PRODUCT CHANGE NOTIFICATION (PCN)

AMJE0909-0030-YEB-24
MODULAR CABLE

CHANGE NOTIFICATION: PCN 20220509_AMJE0909-0030-YEB-24

DESCRIPTION OF CHANGES:
CHANGE OF DATA SHEET
CHANGE OF DATA SHEET
New Draw.-No. ASS_7945_CArev02

AMJE0909-0030-YEB-24 OLD VERSION

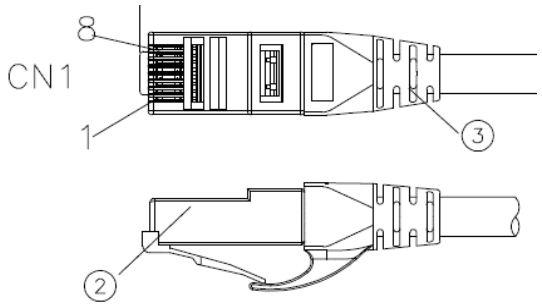
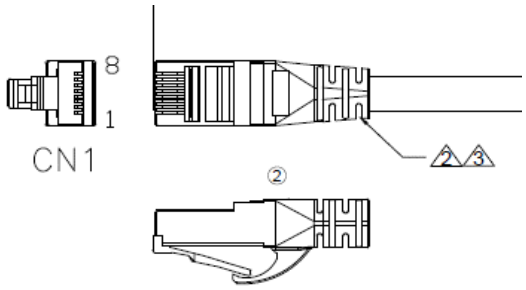
③	Molding	PVC 45P Color: see order code	NA	KG
②	CONNECTOR	RJ45 8P8C two fork Short type 3u" gold plated	2	PCS
①	CABLE	CAT6 UTP (24AWG*1PR)*4+PVC OD=5.8±0.3MM Color: see order code	NA	MM
NO:	NAME	DESCRIPTION	Q'TY	UNIT

3	Molding	PVC 65P Color: see order code ②	NA	KG
2	CONNECTOR	RJ45 8P8C PLUG 3u" gold plated ②	2	PCS
1	CABLE	CAT6 U/UTP (24AWG*1PR)*4+Cross+PVC Jacket OD=5.8± 0.3MM Color: see order code ②	NA	MM
NO:	NAME	DESCRIPTION	Q'TY	UNIT

Drawing-No.
ASS 7945 CA

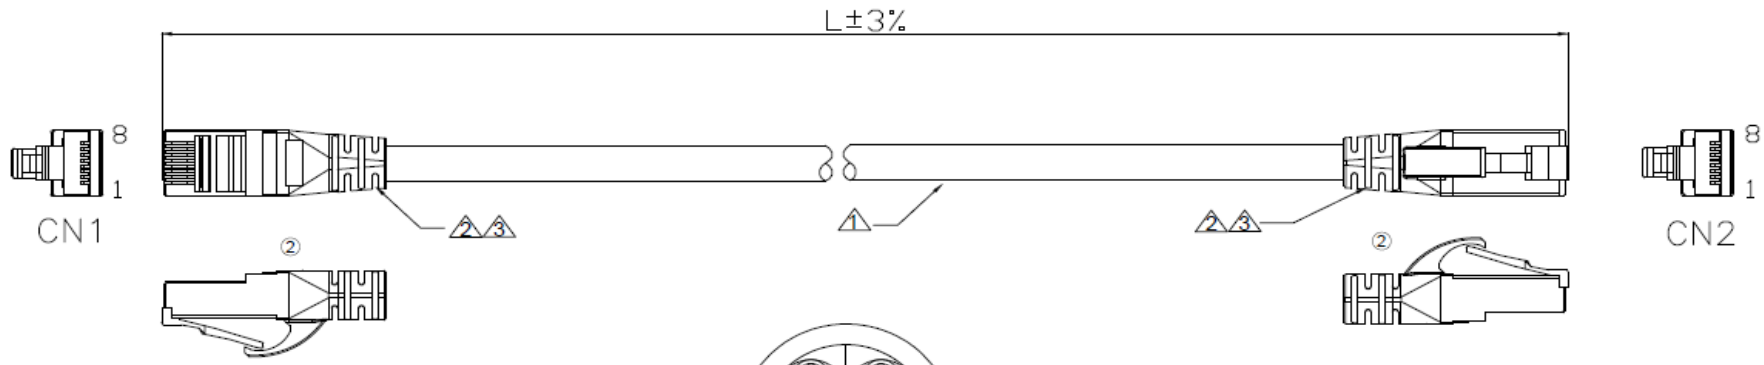
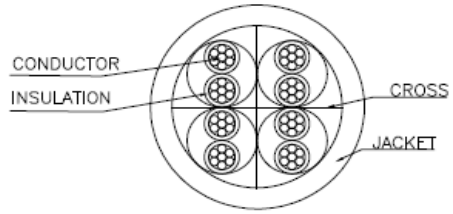
Id.	Modification	Date	Name
②	Change the plant	09.05.2022	Luca
①	Update the WSW order code	02.06.2017	Amy
⓪	Drawn	30.03.2017	Amy

NO:	NAME	DESCRIPTION	Q'TY	UNIT
3	Molding	PVC 65P Color: see order code ②	NA	KG
2	CONNECTOR	RJ45 8P8C PLUG 3u" gold plated ②	2	PCS
1	CABLE	CAT6 U/UTP (24AWG*1PR)*4+Cross+PVC Jacket OD=5.8± 0.3MM Color: see order code ②	NA	MM
